Informal document GRB-58-07
(58th GRB, 2-4 September 2013,
agenda item 3(a))

Two, three or others?

China Automotive Technology and Research Center

ASEP: Vehicle A

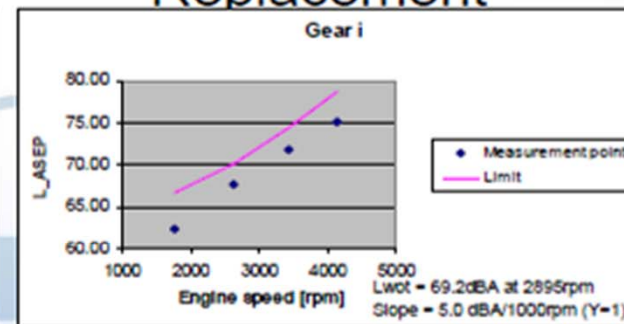
Set the same top line for different vehicles
is not appropriate

- This sports car has 515kW engine with 355/25 ZR21 tire.

- This car has 26kW engine with 145/70 R12 tire.

- Our opinion is not use 2.0m/s^2 or 3.0m/s^2 as the top line for acceleration, but use a formula which is related to a_{ref} :
- The top borderline for acceleration should be
 - **$(a_{\text{ref}}+0.5) \text{ m/s}^2$**
- This kind of thought comes from the spirit of ASEP, and the a_{ref} is the acceleration we really want to get during WOT noise test, so the purpose of the top border line should also helpful to make the test acceleration of vehicle close to the a_{ref} .
